SPARTAN CHASSIS, INC.

TSB05-170-003

TECHNICAL SERVICE BULLETIN

- SUBJECT:** Engine Oil Leak – Cummins C8.3, ISC, ISL, ISM
- APPLIES TO:** Certain Spartan Chassis Models Equipped with a Cummins C8.3, ISC, ISL, or ISM Engine, with a VDM (Vehicle Date of Manufacture) between September 2002 and April 2005.
- CONDITION:** The plastic engine oil dipstick tube may melt as it could be located in a manner that it is subject to contact with a heat source in the engine compartment.

FIG. 4-1

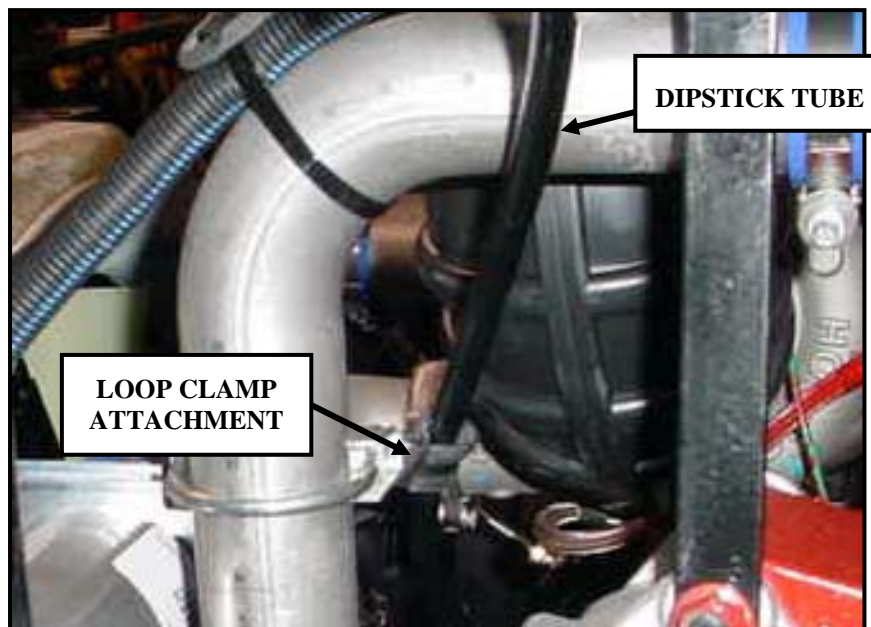
4. To prevent contact with the turbo or any other heat source, secure dipstick tube with the loop clamp provided to an appropriate location as shown in FIG. 4-1, FIG. 5-1, or FIG. 6-1.

Note: Plastic tube must be a minimum of 2.0 inches from the turbo unit or any heat source (i.e. turbocharger, exhaust piping, hot water piping, etc.)

FIG. 6-1

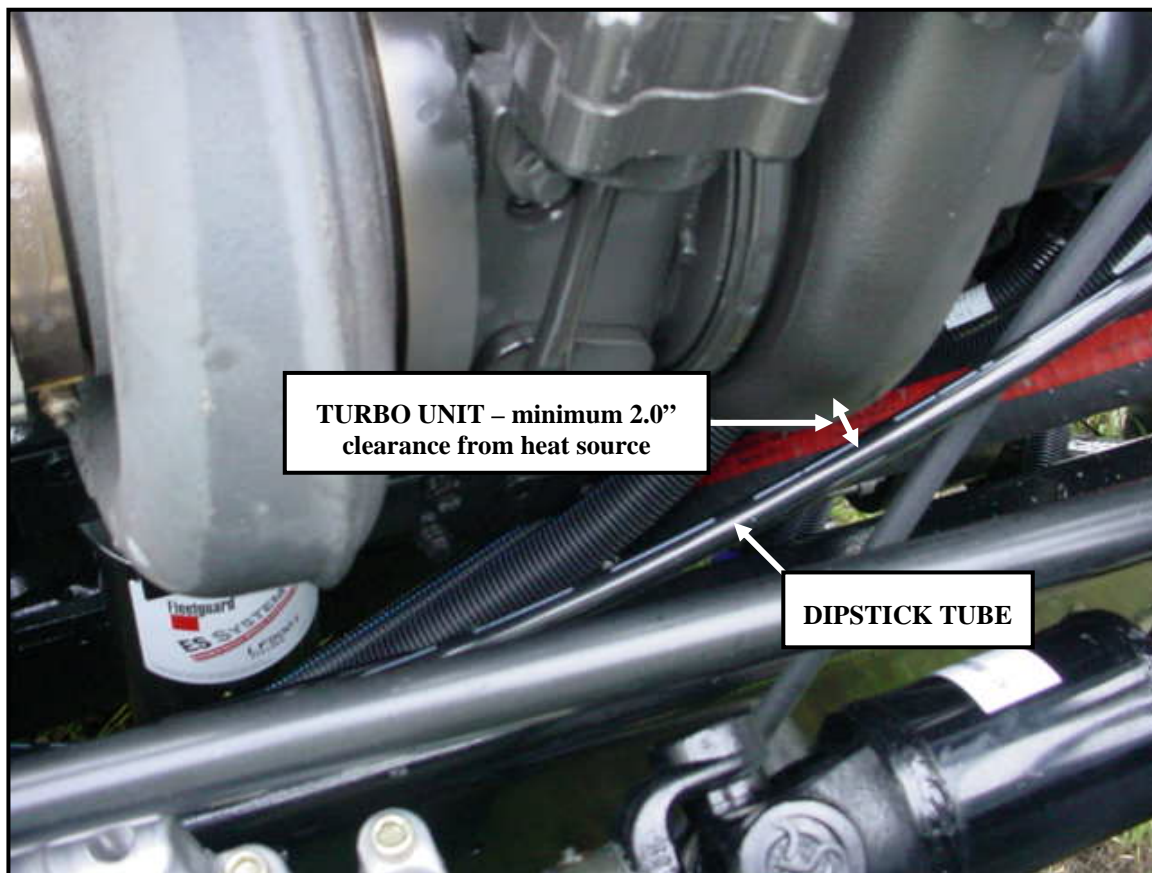
Note: Care must be taken with new tube installation and routing to not to kink the plastic tube, as this will cause resistance when inserting and/or removing the dipstick.
